CK'D BY **CLB** OK'D BY **CWC**
 April 13, 2018
 RESUBMIT **NO** Approved **AsNoted**
 BY **C. CARLSON** DATE **04/27/18**

HIGHWAY SAFETY CORP		CERTIFIED FABRICATOR
GLASTONBURY, CT 860-633-9445		
ITEM 525.335 BRIDGE RAIL, GALVANIZED, 3 RAIL BOX BEAM ITEM 621.725 GUARDRAIL APPROACH, GALVANIZED, 3 RAIL BOX BEAM VT RT 15A BRIDGE No. 1 TOWN OF MORRISTOWN - LAMOILLE COUNTY, VT BRS 0240(3) S		HSC JOB NO. 2236
GENERAL CONTRACTOR		SHEET NO. 8 of 8
SUB CONTRACTOR LAFAYETTE		
DRAWN PAR	CHECKED	DATE 04-09-18
	SCALE NONE	SIZE D

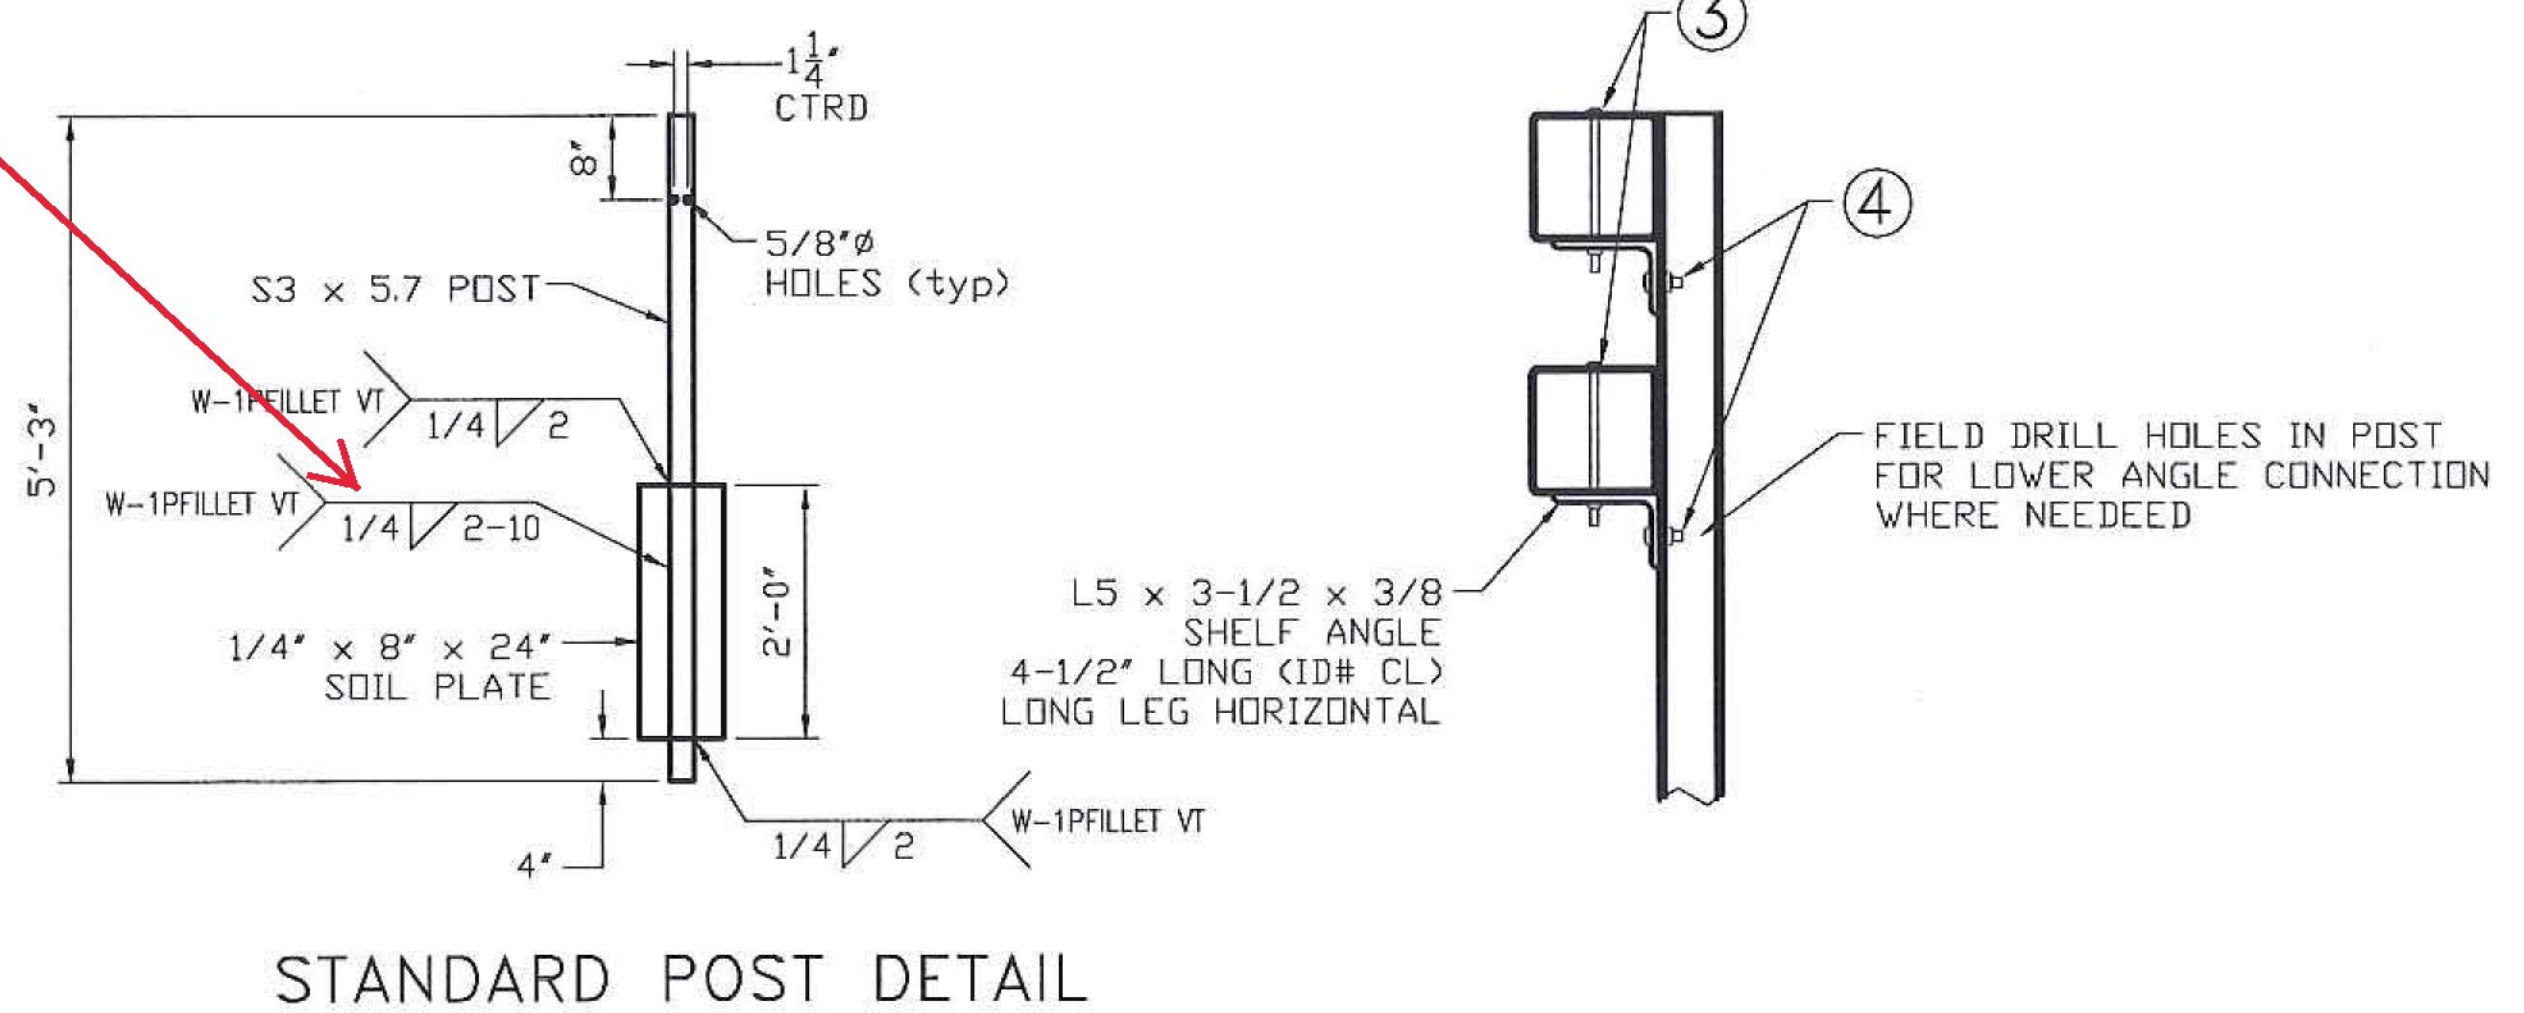
Should be both sides of joint
